Rezoning Transportation Analysis

Petition Number	2016-089	Updated	8/25/2016		
Location	Approximately 4.35 acres located on the south side of DeArmon Road between Mineral Ridge Way and Hampton Place Drive.				
Staff Resource	Rick Grochoske	rgrochoske@c	charlottenc.gov	704.432.1556

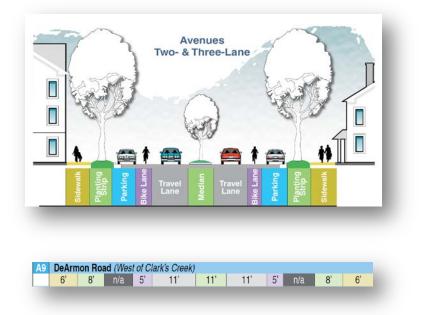
- CDOT recommends coordination with Kristie Kennedy (Engineering Property Management, 704.336.6194) to confirm or correct the cross section in the Prosperity Hucks Area Plan (see below) to conform to the City's Farm to Market upgrade project.
- 2. The petitioner should revise the site plan to identify and construct the pavement, curb line, planting strip and sidewalk in accordance with the City's future plan along the site frontage along DeArmon Road. Per the Prosperity Hucks Area Plan (see below) the site plan should show curb and gutter 24' from existing centerline. After meeting with City staff, DeArmon Road widening and street streetscape improvements will be implemented by the City.
